I405 Brickyard Sediment Sizing Discussion Agenda

I405 Brickyard - Juanita Skanska's Email Questions

Figure 8.1.10-1 Scour without Lateral Migration

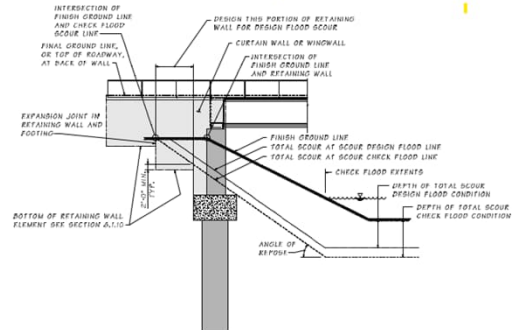
What was the calculation for scour depth including lateral migration versus not including lateral migration inside the tunnel?

- Scour depth within the tunnel is not affected by whether lateral migration is included
- Fig 8.1.10-1 Scour without Lateral Migration, shows bottom of scour prism = check flood extents; check flood reaches tunnel walls --> ignoring lateral migration doesn't impact sediment depth
- Final sediment gradation has not been finalized
- Assuming final D50 is approx. 4", scour depth is less than 1 foot
- Min. thickness streambed sediment = total scour + 2 ft

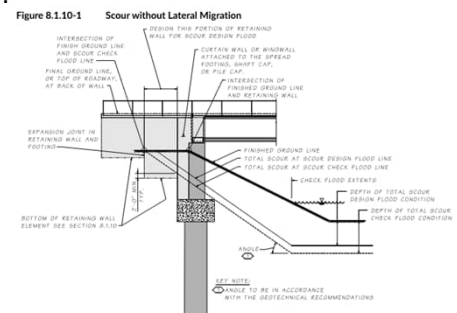
Why was lateral migration included here? We fought so hard to not include lateral migration at the Sammamish River but seemed to accept it here. Please explain.

- The version of the FHD cited in the email was from before we received guidance to ignore lateral migration. This section of the FHD will be updated.
- Sonia closed RCSR comments on lateral migration on July 28, 2025
